Process Sheet

Customer : CU-DAR001 Dart Helicopters Services

Part Number : D3562041

DESIGN	DRAWN BY	DART AEROSPACE LTD HAWKESBURY, ONTARIO, CANADA
CP	CP	
CHECKED	APPROVED	DRAWING NO.
CP	CP	D3562
DATE	TITLE	REV. B
07.01.15	STEP ASSEMBLY	SHEET 1 OF 1
A	NEW ISSUE	SCALE
B	ARMS NOW RIVETED TO STEP	NIS

TYPICAL STEP END DETAIL
NOT TO SCALE

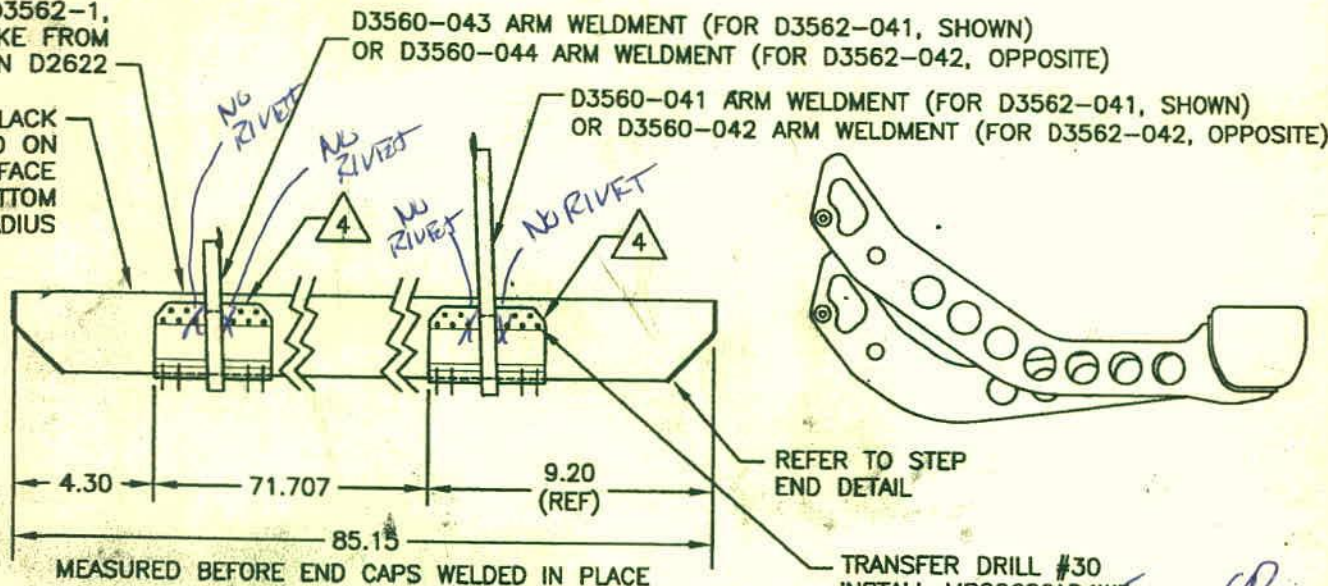
ROUND CORNER OF EXTRUSION TO
MATCH BEND RADIUS OF END PLATE

For the D3562-041/-042 step weldment, as discussed. They want to switch from Sikaflex to Magnabond, and powder coat after final assembly.

For the D3562-041/-042 Step Assembly, we need to remove qty(1) rivet from each D3560-XX Arm weldments attachments for manufacturability. There will be a total qty(34) MS20600AD4 rivets instead of qty(36) per step. The rivet will be removed from the side surface of the step. Remaining shear would be 350 lbs x 16 rivets = 5600 lbs per arm attachments.

For the D3562-041/-042 step weldment, when doing the actual assembly, it was discovered that the rivets on either side of the arm cannot be installed because of problems fitting the rivet tool. Total number of rivets will not be 32 per step assembly (was 36).

As we have discussed previously, this is acceptable as long as the Magnabond doesn't break down.

As we discussed, I think this change is acceptable without further qualification.

Acceptable deviation.
